College Park Site "A"

Preliminary Drainage Study

Rocklin, California

December 2019
Revised January 2021
Revised April 2021

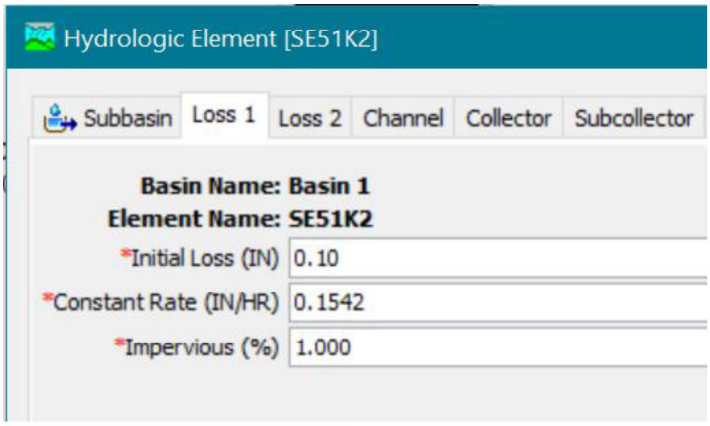
1. The project site is in the Secret Ravine watershed. Tributary to the Dry Creek watershed. Recommend the report include a pre- and post-project condition hydrologic model evaluation for the overall Secret Ravine watershed (see Placer County Flood Control website) to determine if the on-site detention basins are properly mitigating the 2-, 10-, 100-year flows. The goal is to determine if the post-development outflow hydrographs and timing from the proposed basins are close to pre-development conditions and will not adversely impact the overall watershed.

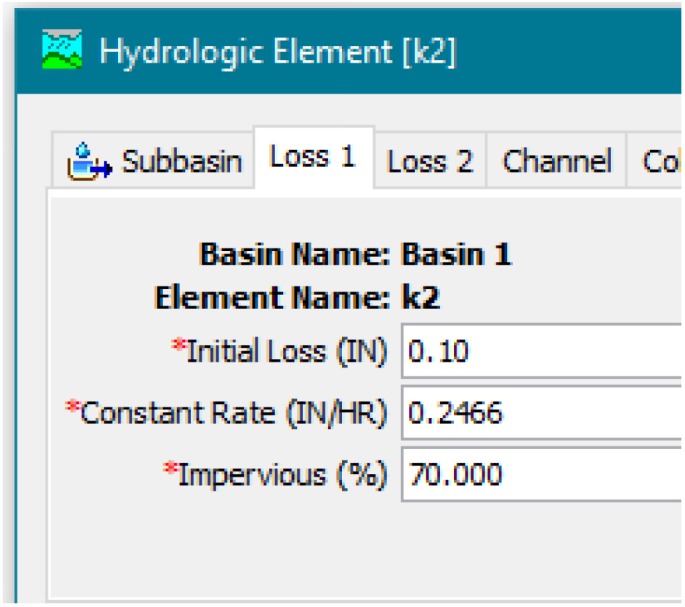
2. The target existing condition outflows for the 2-, 10-, 25- and 100-year for the proposed detention basins need to be discussed in the report. Review the Placer County Stormwater Management Manual to determine mitigation goals for the basin outflows and provide a summary table which includes a comparison for pre-, post with and without mitigation.

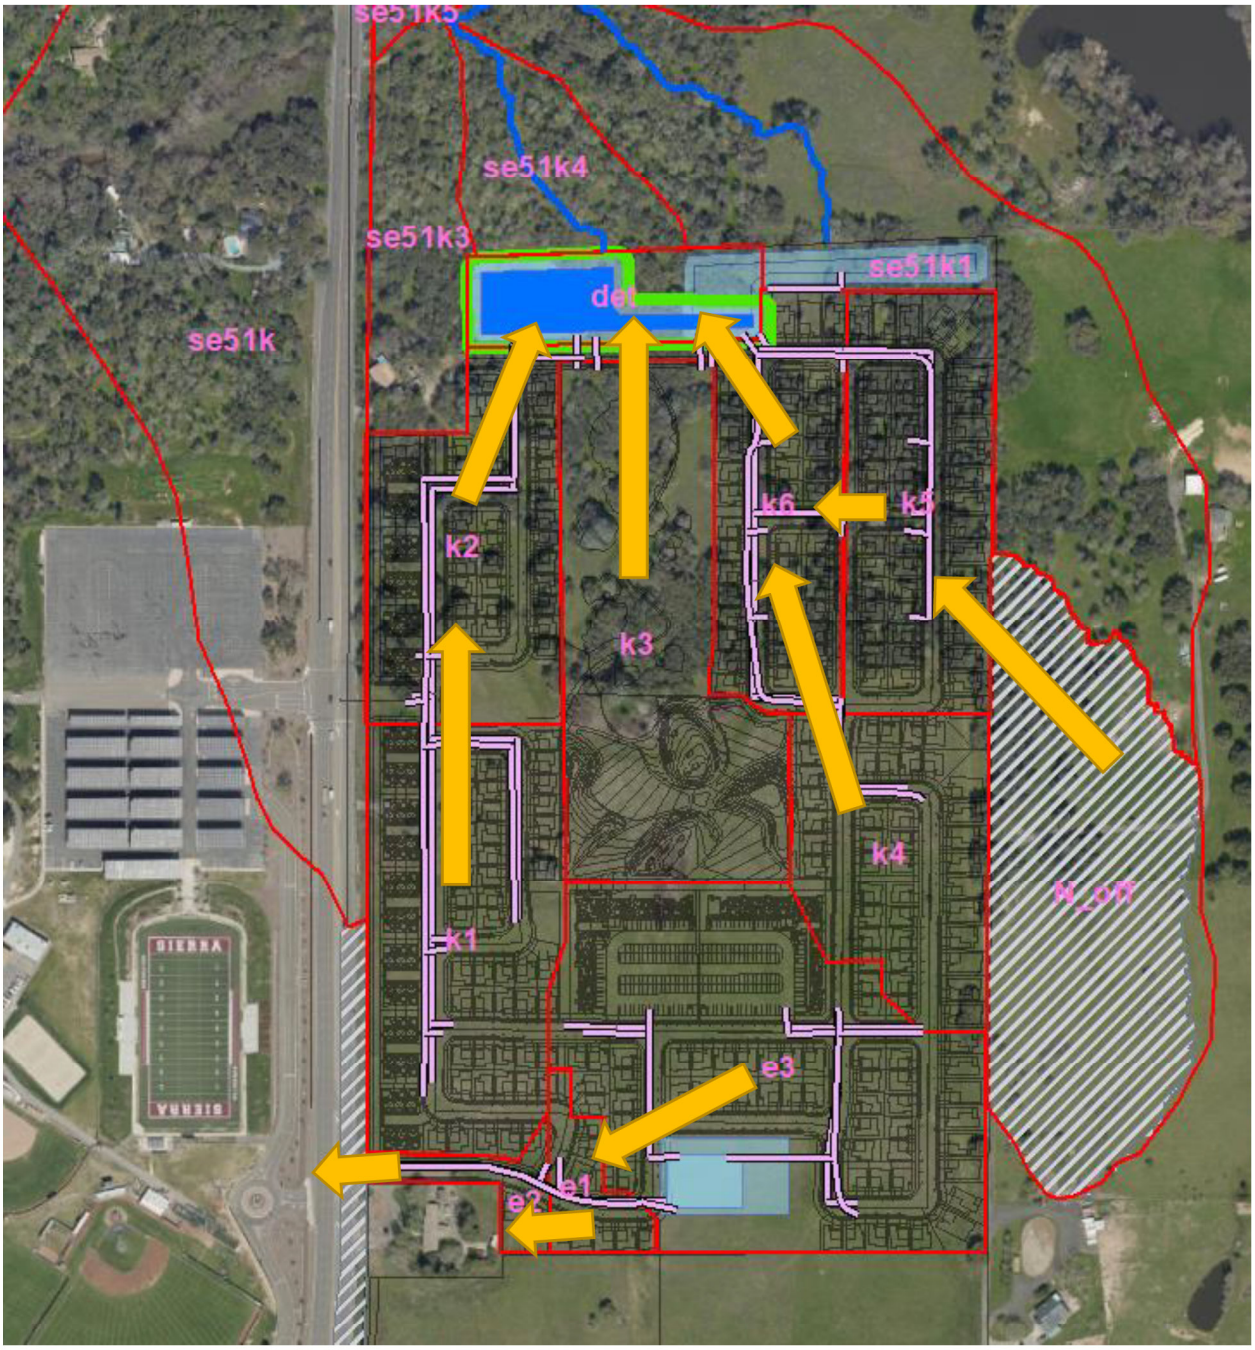
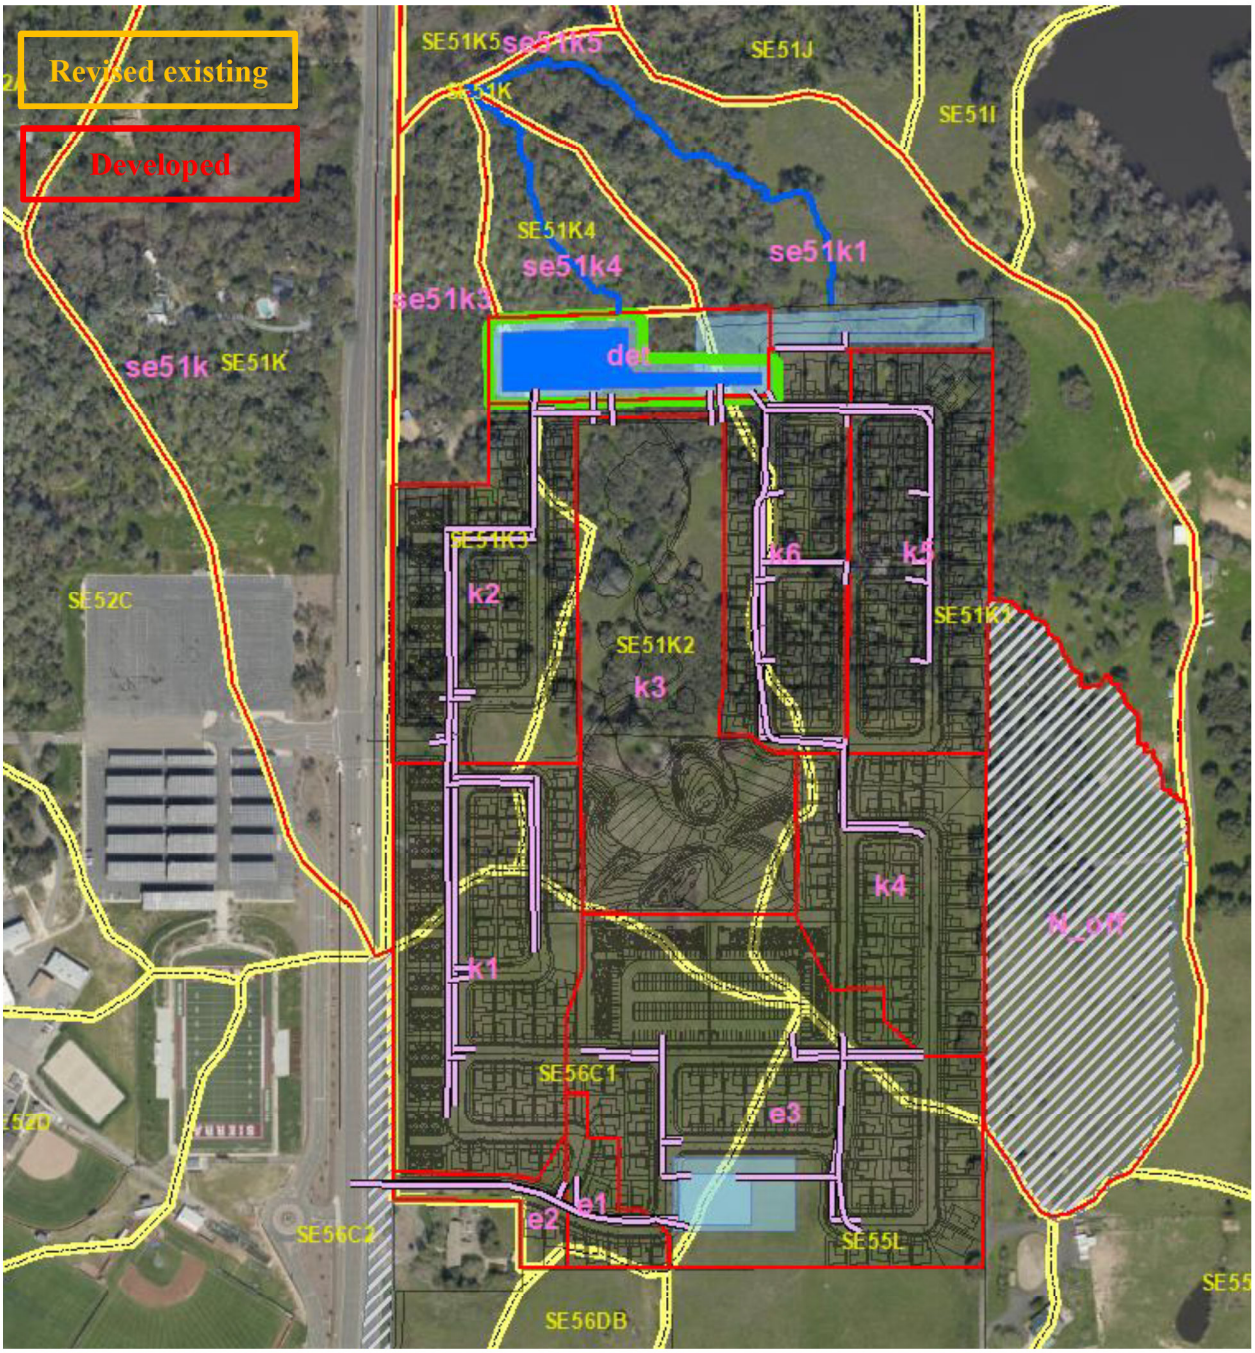
7. The routing diagrams for the SWMM model shown below should be discussed and included in the drainage reports. The comparison between revised existing catchments and developed catchments is shown below:

8. The routing diagrams for the SWMM model shown below should be discussed and included in the drainage reports. The comparison between revised existing catchments and developed catchments is shown below:
Routing diagram is acceptable and is helpful to be included in the report.

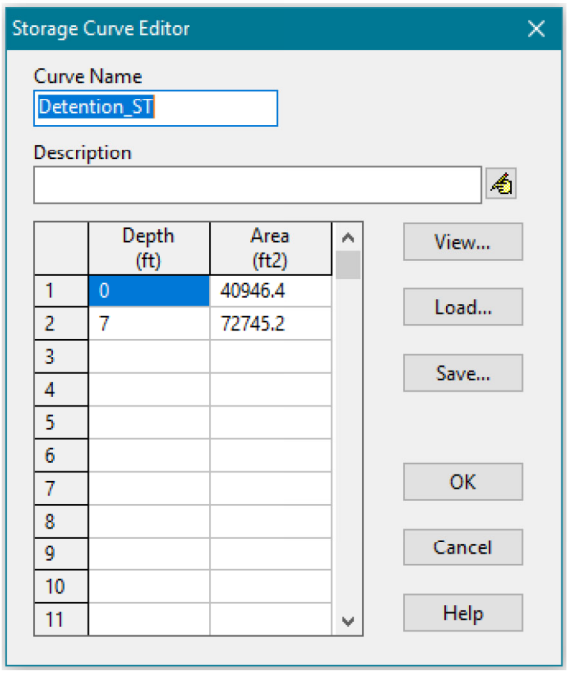
8. There are several locations that the draft report does not match the SWMM model. Please confirm.

- Report indicates a 5.6 acre-ft detention basin is placed on the northern boundary, but the SWMM potentially shows it is actually ~ 9 acre-ft. Please confirm.

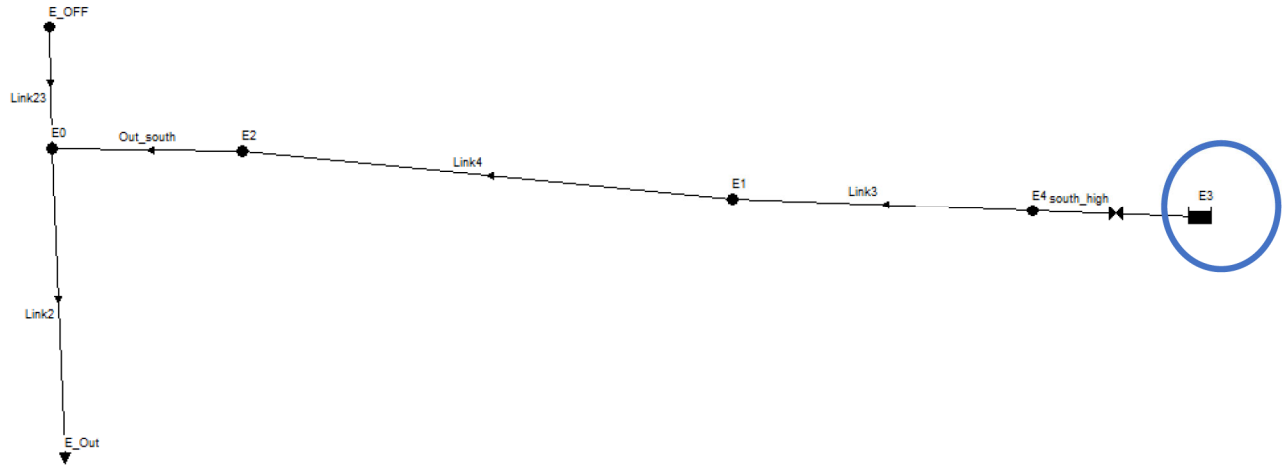
- Report indicates there are two 6'' diameter and one 12'' diameter pipes out of northern detention basin. But the SWMM model has different orifice dimensions (north_wq, north_low, north_high). Please correct the model or the report.
